Product Change Notification

Change Notification #: 115268 - 02
Change Title: Select Intel® SSD DC S3610 Series Products, PCN 115268-02, Product Design, Power Loss Imminent (PLI) Capacitor Relocation
Reason for Revision: Posting PCN to Public QDMS
Date of Publication: April 17, 2017

January 27, 2017 Changes:

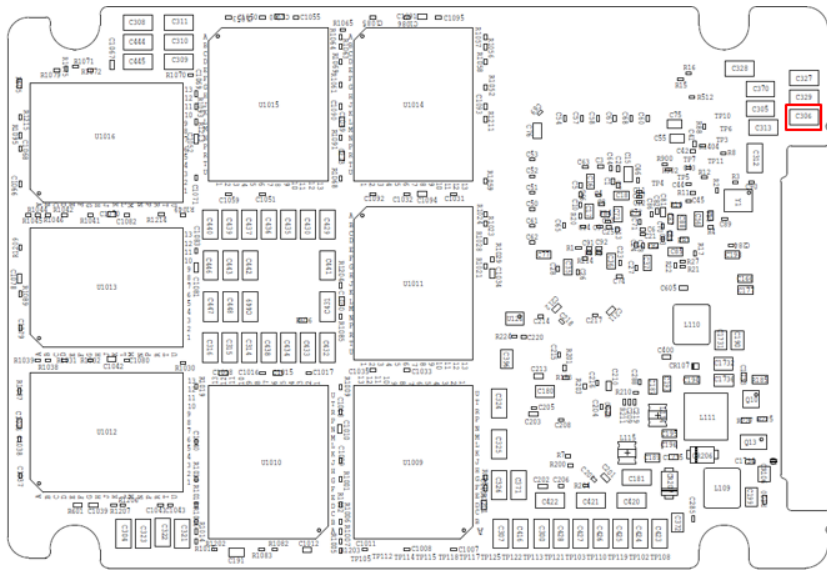
From: To reduce potential mechanical strain, two 0805 MLCC capacitors are placed instead of one 1206 MLCC PLI capacitor, total PLI capacitance is equivalent as before the change. The PLI Capacitors have been relocated to a lower risk location on the Printed Circuit Board (PCB) on select Intel® SSD DC S3710 Series products. Please see the Products Affected/Intel Ordering Codes table below.

To: To reduce potential mechanical strain, two 0805 MLCC capacitors are placed instead of one 1206 MLCC PLI capacitor, total PLI capacitance is equivalent as before the change. The PLI Capacitors have been relocated to a lower risk location on the Printed Circuit Board (PCB) on select Intel® SSD DC S3610 Series products. Please see the Products Affected/Intel Ordering Codes table below.

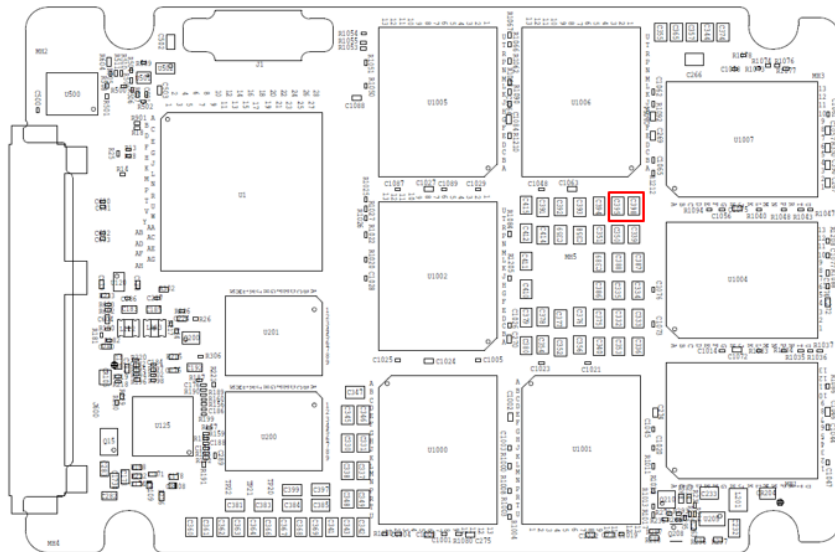
To reduce potential mechanical strain, two 0805 MLCC capacitors are placed instead of one 1206 MLCC PLI capacitor, total PLI capacitance is equivalent as before the change. The PLI Capacitors have been relocated to a lower risk location on the Printed Circuit Board (PCB) on select Intel® SSD DC S3710 Series products. Please see the Products Affected/Intel Ordering Codes table below.

PLI capacitors in the current PCB location may experience potential mechanical strain during drive insertion and/or removal. This potential strain may induce mechanical damage to the PLI capacitors, which may lead to capacitor damage and/or failure.

Current capacitor location:

New capacitor location:

This change relocates existing capacitors (total PLI capacitance is equivalent as before the change) to lower risk positions on the same PCB. The original mechanical qualification remains valid for this change. Customers should be aware and familiar with this PLI change.
